Final Review and Recommendation 2020 RTEP Proposal Window 3

January 8, 2021

2020 RTEP Proposal Window No. 3

Figure 1 – West Mount Vernon - Mount Vernon 69 kV

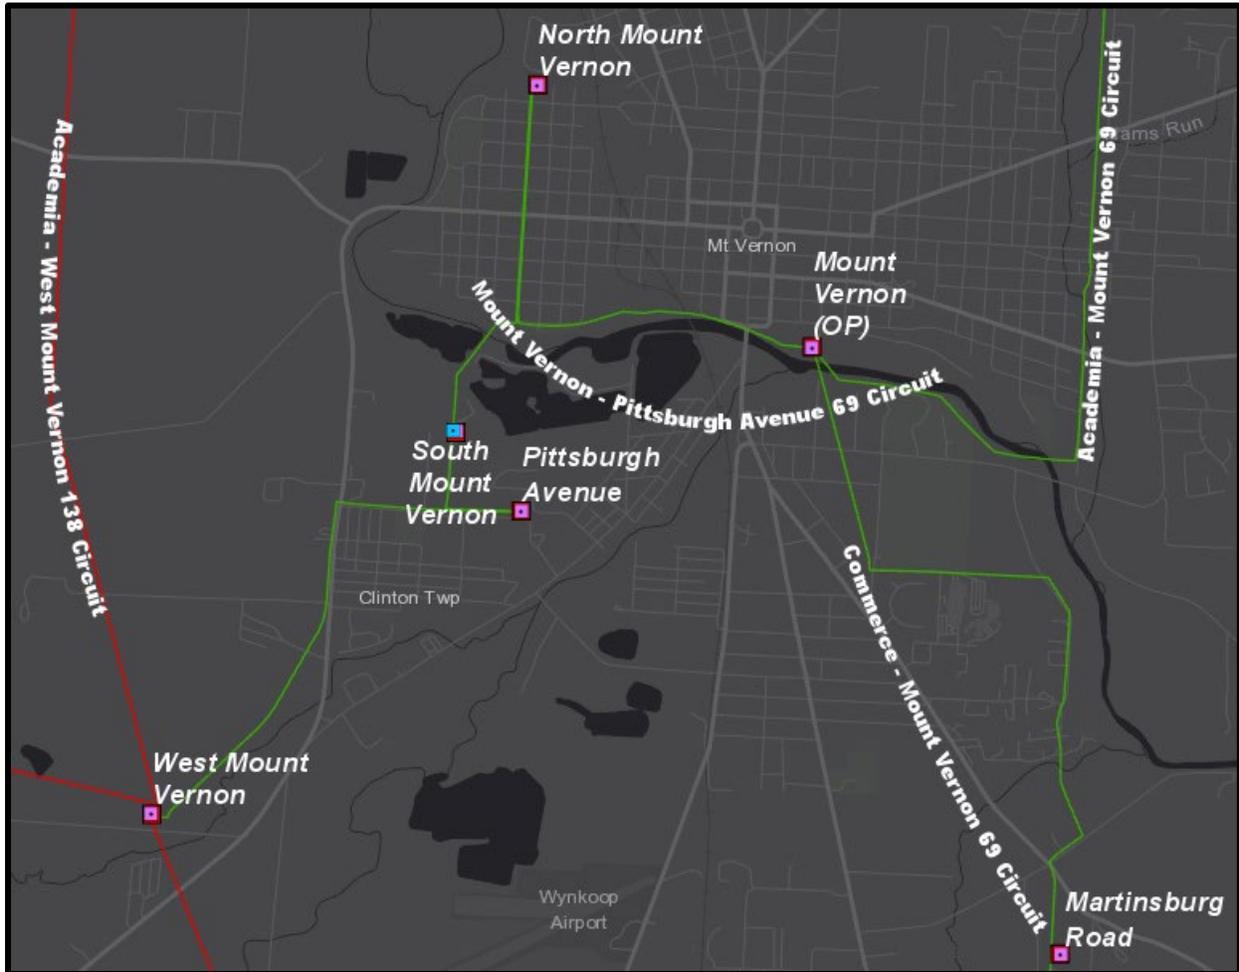
PJM also notes that Proposal No. 533 incorporates Greenfield construction that will require new or additional easements, and siting of a new 345kV substation. The proposing entity believes that the existing Gambier 69V substation can be expanded inside the existing substation fence line to accommodate a new 69kV line from the new 345kV substation. This siting of a new 345kV substation offers some significant risk to the proposal.

A review of these overlaps as part of PJM's 2020 Window No. 3 screening has identified secondary benefits beyond solving identified reliability criteria violations. Based on the information provided by the sponsor, Proposal No. 860 will address needs associated with aging infrastructure as outlined below:

- Project will replace a 1950's wood pole line that utilizes copper conductor. Proposal will also replace a 1952 vintage 138/69 kV transformer along with a 1951 oil breaker at West Mount Vernon station.

- From 2015 – 2020 this circuit has experienced 2 momentary and 5 permanent outages resulting in approximately 21k CMI.
- The circuit currently has 45 open conditions on 38 structures (49% of the total structures), including pole damage, top rot, heart rot, and missing ground lead wires.
- Structures are made up of wood poles from the 1950s (50 structures). Some structures have been replaced since the 1980s (28 structures).

- The circuit conductor was installed in 1952 consisting of 3/0 Copper.

Proposal No. 860 solves the identified reliability criteria violations and offers additional benefits in the form of eliminating an Attachment M-3 need (not observed in the other proposals in this cluster). Proposal No. 697, while indicating less costs for the individual proposal, will not address the existing aging infrastructure issues identified above. Proposal No. 533 offers to solve the violations through addition of a source to the Gambier 69kV substation, which currently does not have facilities with which it might serve the load in the area but would be required should the Attachment M-3 need (indicated as additional benefits for Proposal No. 860) be left unresolved in the future. This would lead to a need for further expansion at the Gambier substation to provide transformation capabilities, as well as additional circuits from Gambier, to serve load addressed in the facilities identified in the additional benefits for Proposal No. 860.

In addition to being more costly, Proposal No. 533 incorporates Greenfield construction which may impact the ability to timely complete the project, while Proposal No. 860, in contrast, is an upgrade to existing facilities. Finally, while cost capping provisions are provided in Proposal No. 533, the costs for Proposal No. 533 are significantly higher than the costs estimated for Proposal No. 860.

Based on this information, Proposal No. 860 is the more efficient or cost effective solution in Window No. 3. PJM's initial planning level cost review and initial feasibility review suggests that further constructability review and financial analysis would not materially contribute to the analysis of the other proposals submitted for this cluster.
